Memo information	
Date	10 February 2024
To	Department of Environment and Science
Prepared by	QCoal Sonoma Pty Ltd
Subject	Sonoma Coal Mine PRCP – Information Request Notice Response

On 30 September 2022, QCoal Sonoma Pty Ltd (QCS) submitted a PRC Plan and PRCP Schedule for the Sonoma Coal Mine (SCM) to the Department of Environment and Science (DES). DES subsequently issued an Information Request Notice to QCS on 28 November 2022, requiring QCS to provide additional information to address identified potential issues with the submitted PRC Plan by 31 May 2023 (subsequently extended to 10 February 2024).

This memo documents QCS's responses to the DES Information Request Notice, as well as detailing other updates that have been made to the SCM PRC Plan and PRCP Schedule.

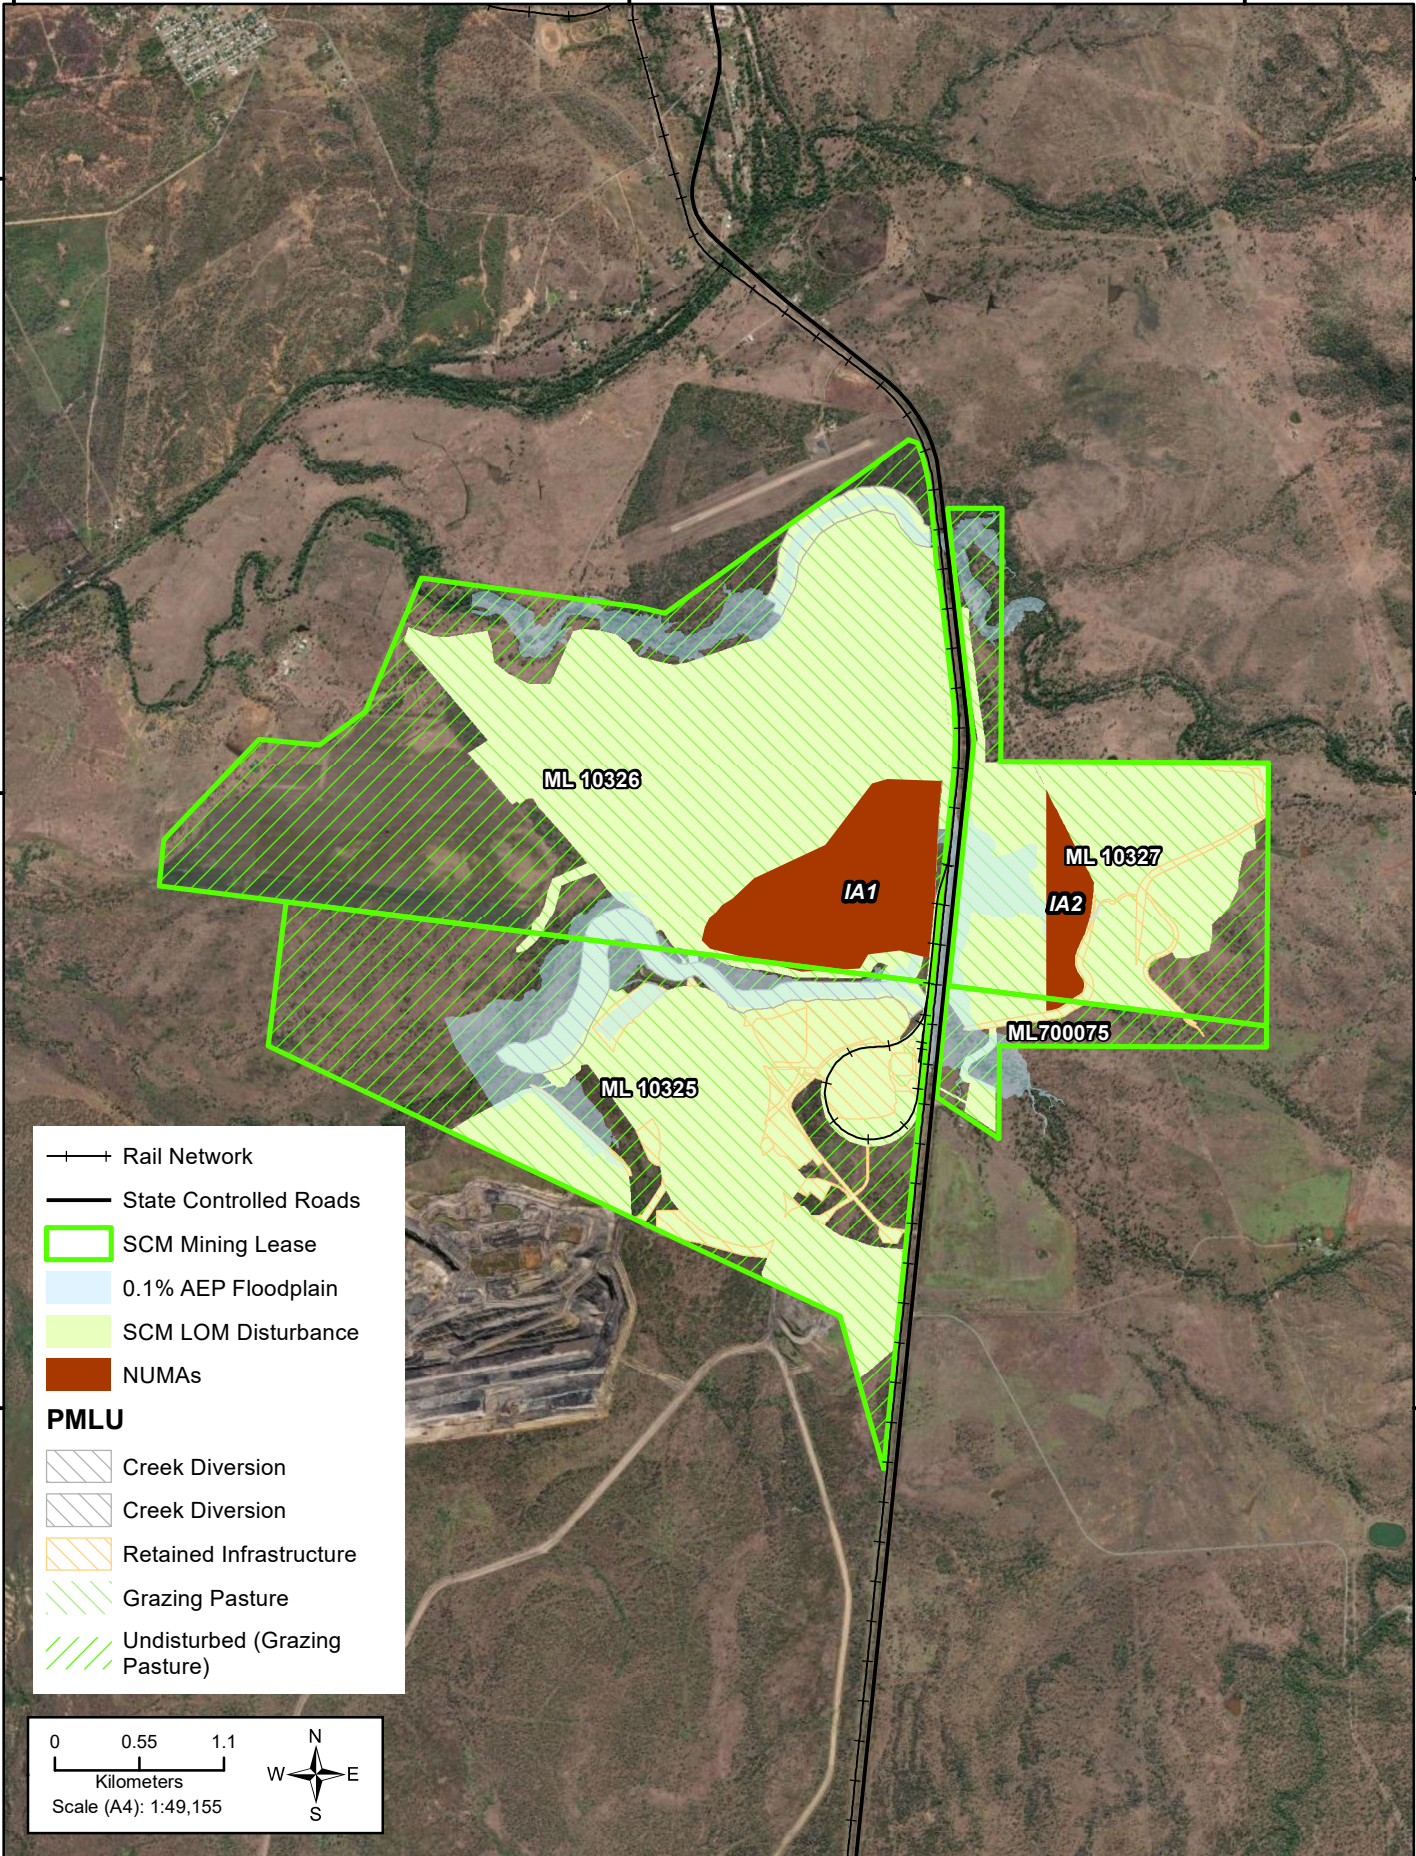
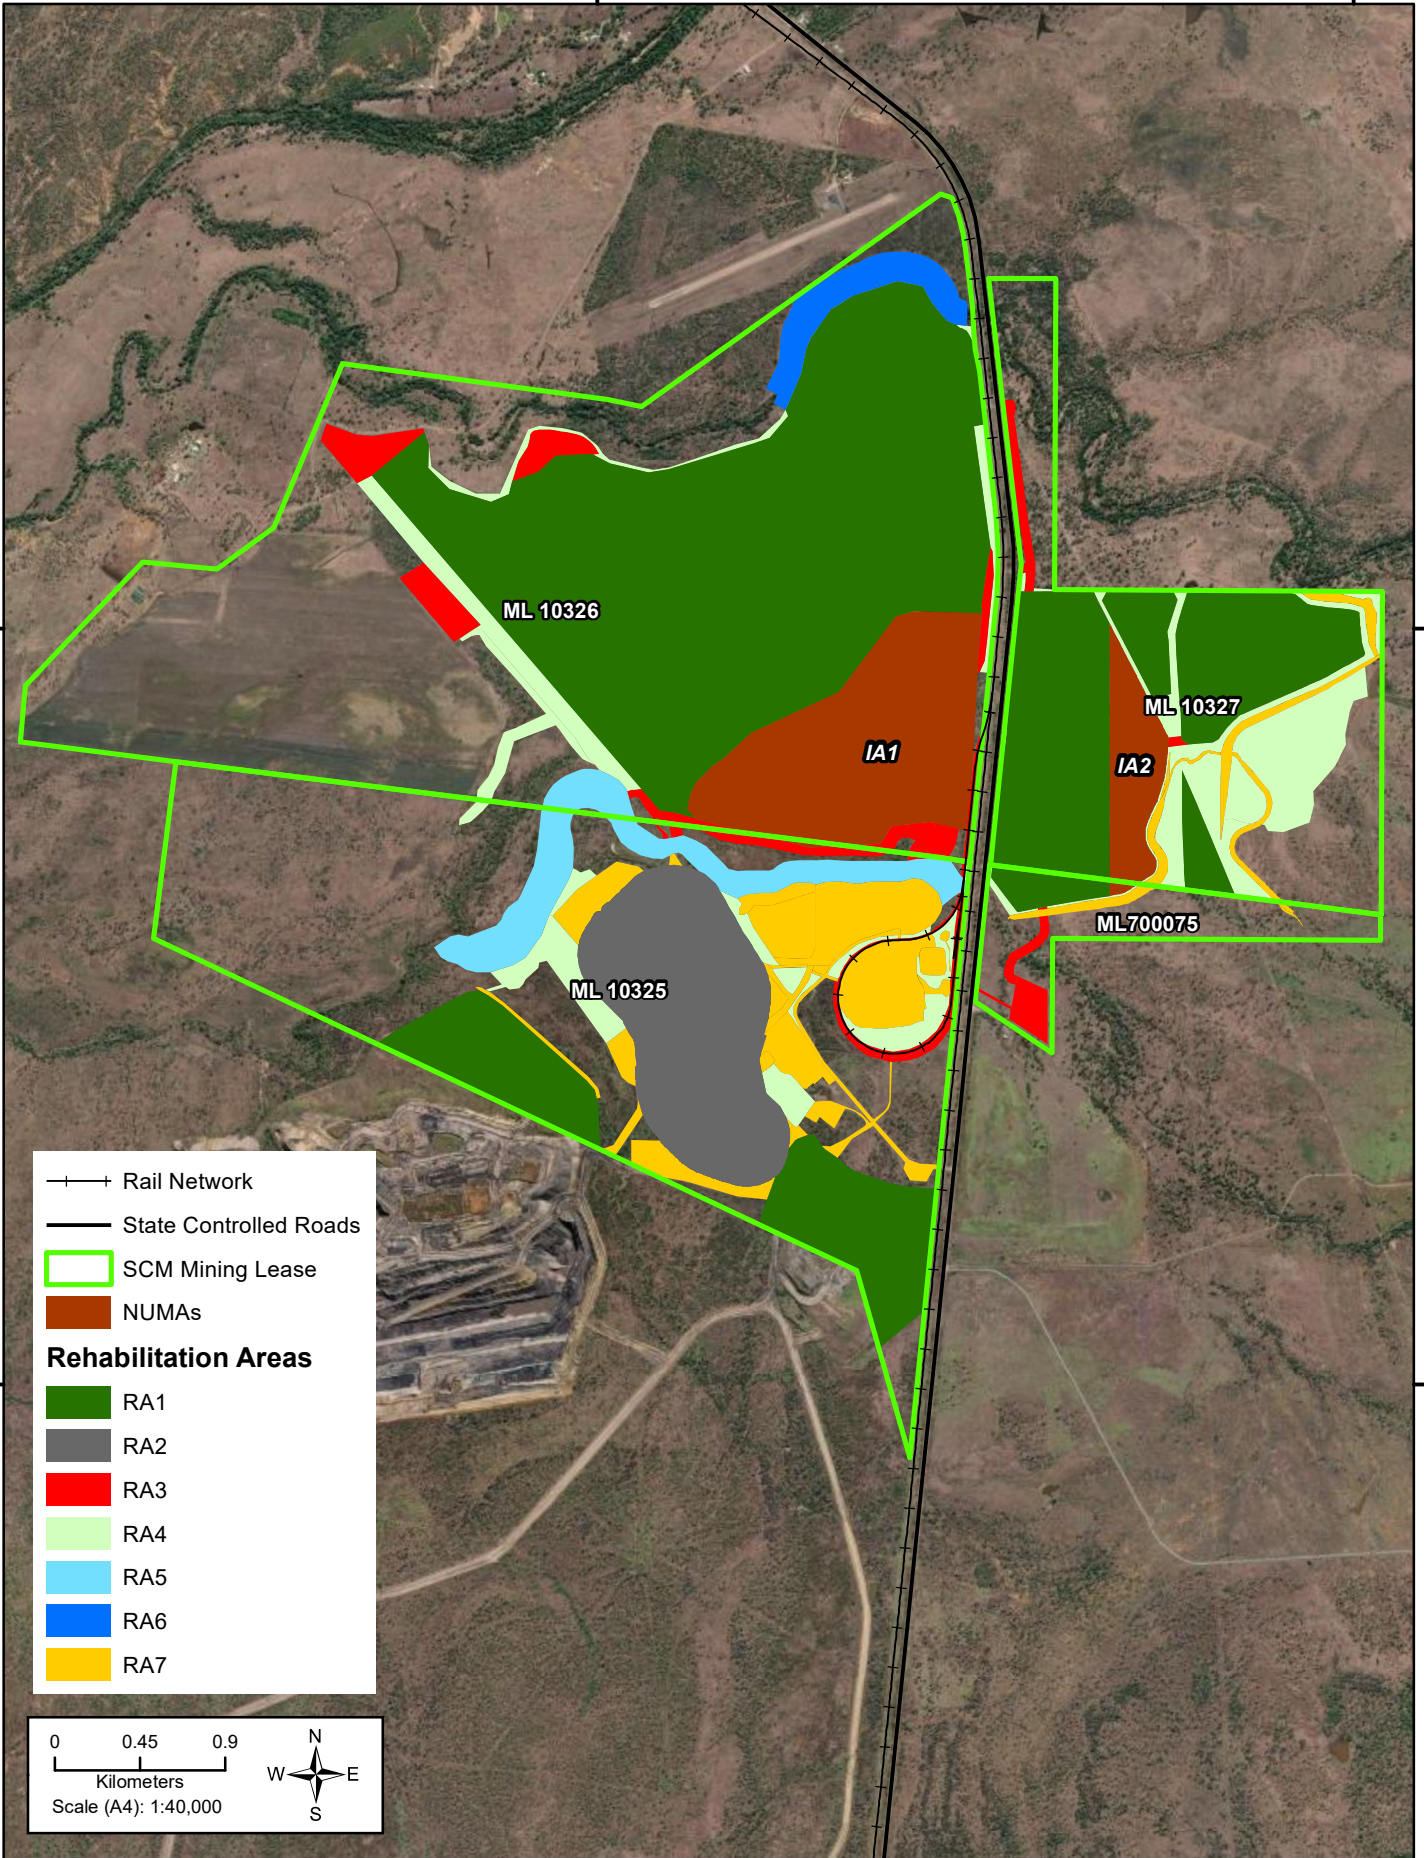
3.0 DESCRIPTION OF CHANGES TO MINE PLAN AND RECONFIGURATION OF REHABILITATION AREAS

Subsequent to the submission of the V1 SCM PRC Plan and PRCP Schedule in September 2022, an application to amend the SCM EA to include a new Mining Lease (Mining Lease Application (MLA700075)) was submitted on 25 November 2022. The SCM EA amendment has progressed to Decision Stage, therefore inclusion in the V2 PRC Plan is considered to be appropriate.

ML700075 is located to the immediate south of the existing ML10327 ('Sonoma East') and will be primarily utilised for the installation of ancillary infrastructure (water management infrastructure, laydowns areas, etc) which will enable the optimisation of the mine plan on the existing ML10327. Only minor mining activities will occur on ML700075 where the endwall of the SCM East Pit extends into the MLA. The addition of ML700075 will maximise the extraction of the remaining coal resources within the SCM MLs and thereby change the areas and duration of activities within the PRC Plan and PRCP Schedule.

The proposed LOM Plan updates have been incorporated into the V2 PRC Plan and PRCP Schedule, which have been prepared in response to the items raised in the DES Information Request issued to QCS on 28 November 2022. The updated layout to the Sonoma East Area LOM Plan can be most clearly viewed in Figure 7 in the V2 PRC Plan. Specifically, the updated LOM Plan has resulted in the following changes to the LOM footprint for the SCM:

Relevant content in the V2 PRC Plan and PRCP Schedule has been updated to reflect these changes as required. While the V2 footprint for several of the SCM RAs have increased slightly above the disturbance areas proposed in the V1 PRCP Plan, the void areas remain consistent with the maximum footprint for voids permitted by the SCM EA.
